## 4.0 Proposed Modified Concept Plan

### 4.1 Modified Concept Plan Development Parameters

Figure 5 – Building Layouts  
Source: Foster + Partners

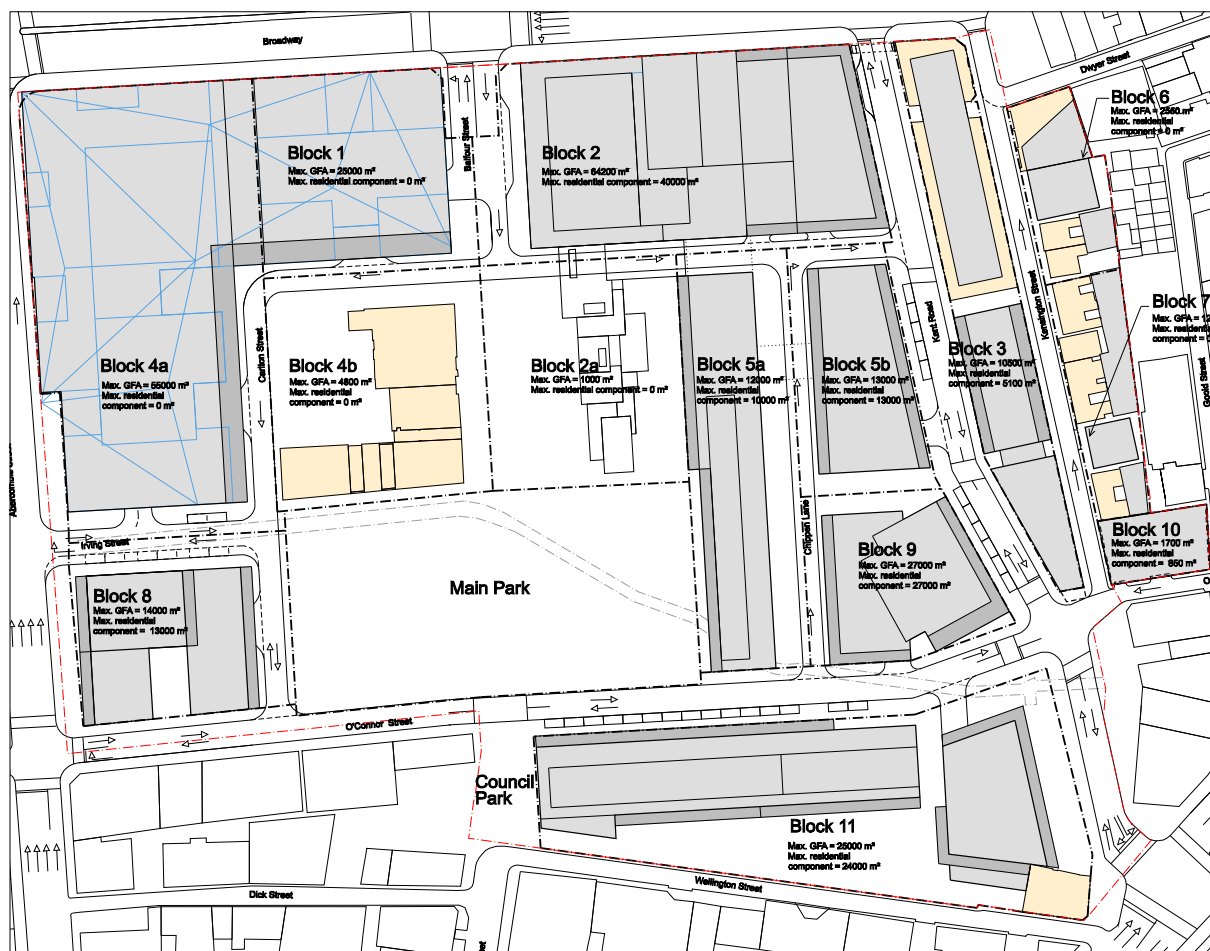
Within the retained 11 block framework / structure established by the urban design structure of the site, a revised built form layout is proposed, as shown in **Figure 5** below and on drawing A-1253 at **Appendix A**.

The primary change to the built form layout is the reconfiguration of Blocks 5 and 9 and the resultant significant expansion of the public domain area. The building which was approved on Block 5 west (now referred to as Block 4c) has been deleted and the GFA formerly proposed in this location redistributed elsewhere on the site. The remaining buildings on Block 5 have been lengthened and reorientated so that they front the expanded park area, providing surveillance and activation. **Figure 6** shows an indicative image of what the public domain might look like.

**Figure 7** – Proposed (Green) and approved (Red) massing on the site  
Source: Foster + Partners

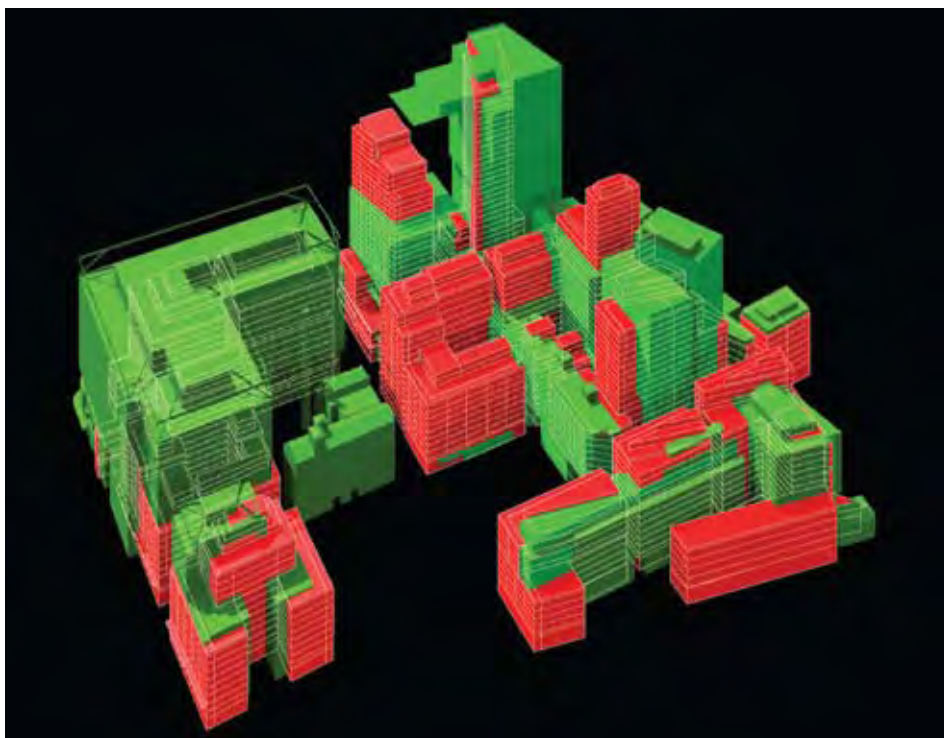
Drawings A-1301 through to A-1311 included at **Appendix A** show isometric views of the proposed modified built form and massing. The images show that the massing of the development has been redistributed on the site so that an increased proportion of the density is shifted closer in proximity to the Broadway frontage of the site. This has allowed for the buildings to be located on the southern portion of the site to be lowered in height and reduced in mass to create a better interface between the proposed development and the adjacent existing development in Chippendale.

With respect to the form of development to be located along the Broadway precinct, the building floor plates have also been reconfigured and enlarged which allows for more useable and viable floor plates to be established for commercial uses. This change also allows for a lowering in the height of some of the buildings along Broadway, and thus provide more sunlight access into the public domain.

**Figures 7 and 8** illustrate the overall massing changes proposed.

**Figure 9 – Proposed modified street layout**

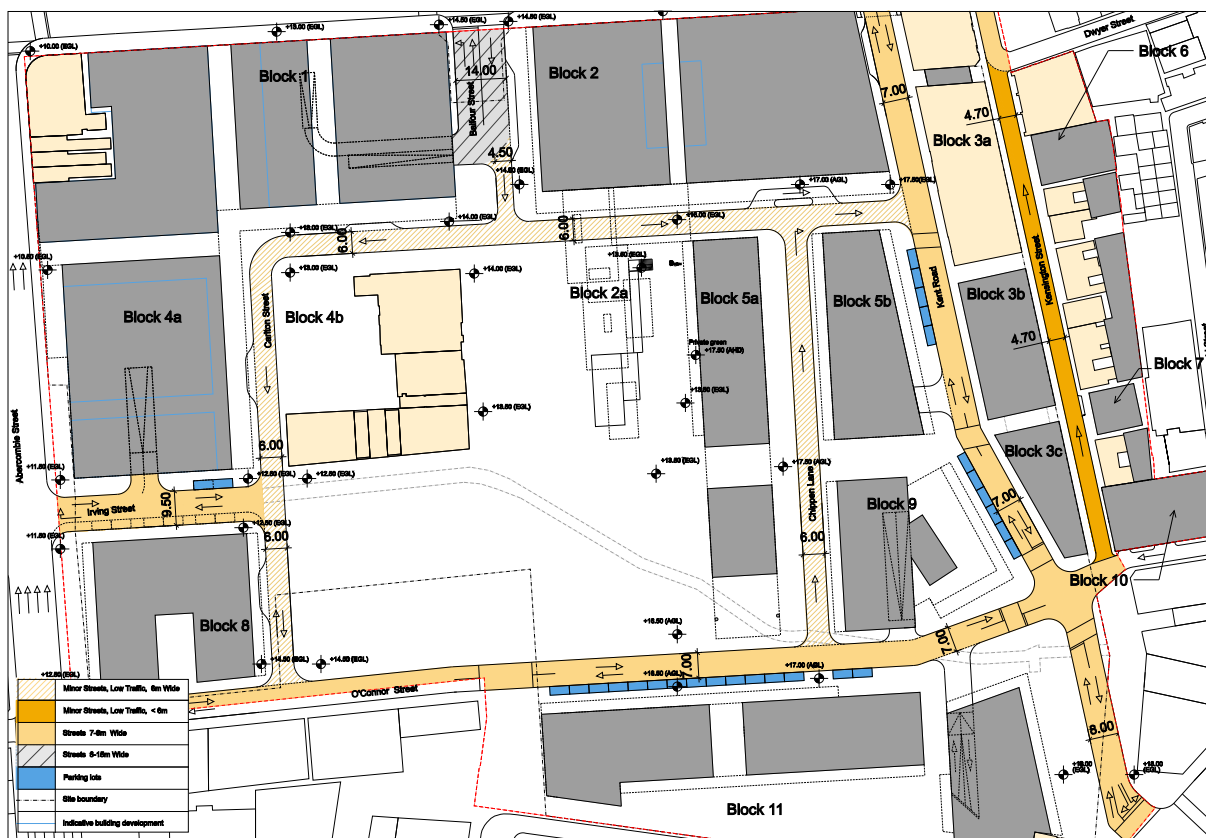
In particular the following modifications are proposed (also see **Figure 9**):

- Closure of Tooth Lane (formally known as Tooth Avenue) to vehicular traffic between Carlton Street and Abercrombie Street.
- Removal of Irving Street between Carlton Lane and Chippen Lane.

- Amalgamations and integration of basement car park areas between blocks and under roads (note - the overall depths of the basements reduce as a result).

- Closure of Kensington Street between Outram Street and Dwyer Street to all but authorised vehicles.
- Extension of Outram Street to Kent Road in a one-way westbound arrangement.

- Relocation of the traffic signals from Abercrombie Street / Blackfriars Street / Irving Street to Abercrombie Street / Irving Street.
- Reduction in the number of vehicular access driveways to basements throughout the site.

- Location of basement car park connections around the periphery of the site to allow vehicles to enter and leave the site close to the surrounding road network.
